ALERT SERVICE BULLETIN

505-17-02

MODEL AFFECTED: 505

SUBJECT: TRANSMISSION OIL MANIFOLD ASSEMBLY,
INSPECTION AND CLAMP INSTALLATION
MODIFICATION OF.

**Figure 1 – Typical Transmission Oil Manifold Assembly Installation
(sheet 1 of 5)**

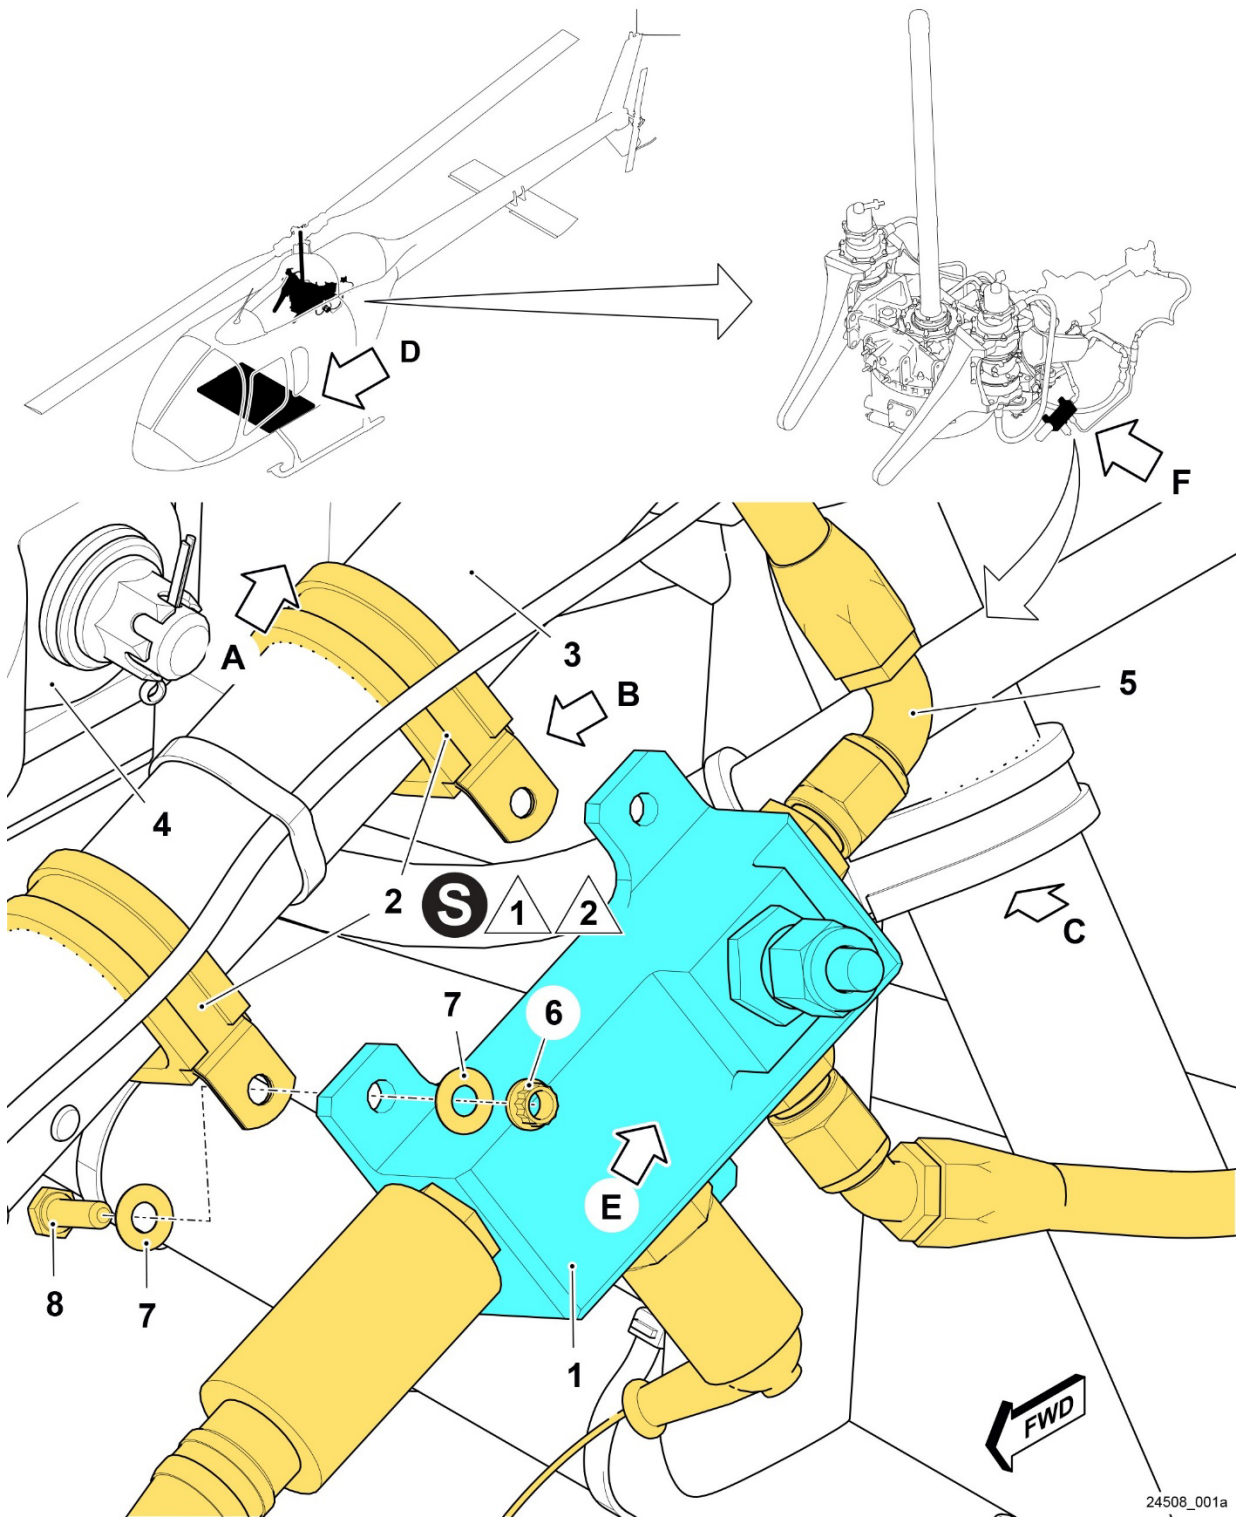
1. Prepare the helicopter for maintenance.
2. Remove upper-left mid-fuselage access panel ([DMC-505-A-53-40-03-00A-520A-A](#)).
3. Inspect clamps (2, Figure 1, sheet 1 of 5) securing the manifold assembly (1) to make sure they have a tight grip and exhibit no easy movement on the truss tube (3).
 - a. If movement of the oil manifold assembly (1) is not possible without much effort, go to step 4.
 - b. If movement of the oil manifold assembly (1) is possible without much effort, following completion of the **PART I** inspection, comply with **PART II** of this bulletin prior to next flight.
4. Inspect the oil pressure line (5) and transmission restraint assembly (4) for damage.
 - a. If no damage is found, go to step 5.

5. Position clamps (2, Figure 1, sheet 1 of 5) and oil manifold assembly (1) on the truss assembly (3) to provide a minimum clearance of 0.300 inch (7.62 mm) between the oil pressure hose (5, Figure 1, sheet 2 of 5) and the transmission restraint assembly (4).

3. Remove clamps (2, Figure 1, sheet 1 of 5) securing the oil manifold assembly (1) to the truss assembly (3) and discard ([DMC-505-A-63-22-10-00A-520A-A](#)). Retain nuts (6), washers (7), and screws (8) for later steps at installation.

4. Clean the truss tube (3) with dry cleaning solvent (C-304) in the area where clamps are to be installed.
5. Inspect oil manifold assembly (1) oil pressure hose (5) for contact with the transmission restraint assembly (4).

**Figure 1 – Typical Transmission Oil Manifold Assembly Installation
(sheet 2 of 5)**

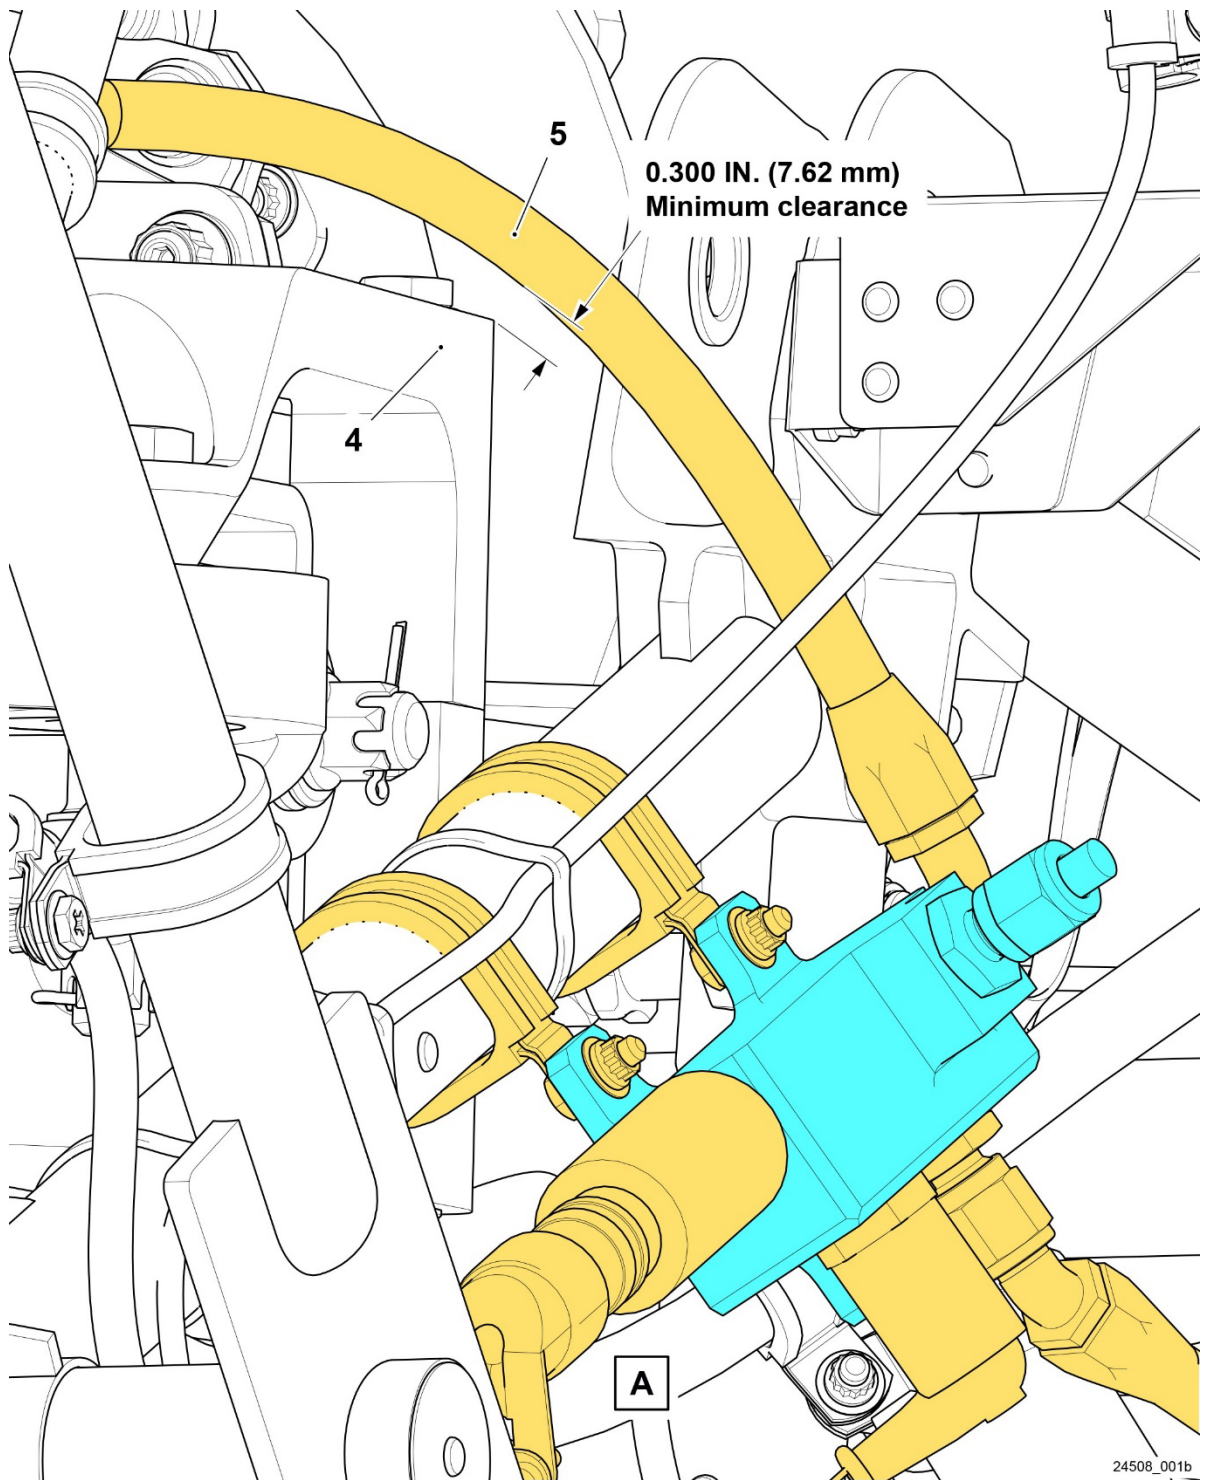
8. As needed, using a digital protractor (or equivalent), “zero” the protractor to the cabin floor as waterline reference point (Figure 1, sheet 4 of 5, View D). Using the “zeroed” protractor, adjust the angle of the oil manifold assembly (1) to approximately 21° (Figure 1, sheet 4 of 5, View E).
9. Verify that there is a minimum clearance of 0.300 inch (7.62 mm) between the oil pressure hose (5, Figure 1, sheet 2 of 5, View A) and the transmission restraint

assembly (4). Adjust the angle of the oil manifold assembly as required per step 8 until measured gap is satisfactory.
